DEPARTMENT OF COMMUNITY DEVELOPMENT SERVICES

m e m o r a n d u m

DATE: November 12, 2015

SUBJECT: DRB-2015-02: A request by Kima Kheiolomoom to construct a new one-car garage on a single-family residential lot in the MOR, Mixed Office Residential Zoning District.

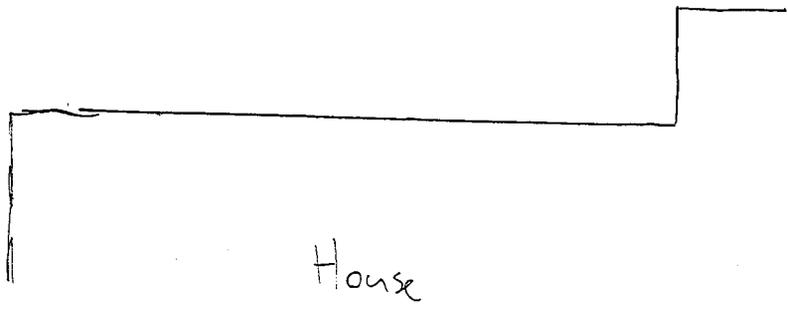
Like the previously existing garage, the proposed garage would have access from the alley on the north side of the subject property. The entry point for the garage would be on the eastern side of the structure with 396 square feet of paved turnaround space available so the exiting vehicle would not be required to back out into the right-of-way. While the garage would only be large enough to hold one vehicle, the overall parking capacity of the property would remain the same.

City staff recommends that the MOR DRB find that the proposal meets the design guidelines for Parking Areas, with the condition that the access drive between the garage and the alley be paved with an approved surface.

1. The garage is constructed as generally indicated on the attached site plan.
2. The access drive between the garage and the alley be paved with an approved surface as required in the Zoning Ordinance such as concrete, asphalt, or permeable pavers.
3. The building material of the garage simulates a lap siding pattern such as the shingle style exteriors found on the surrounding houses in the district.
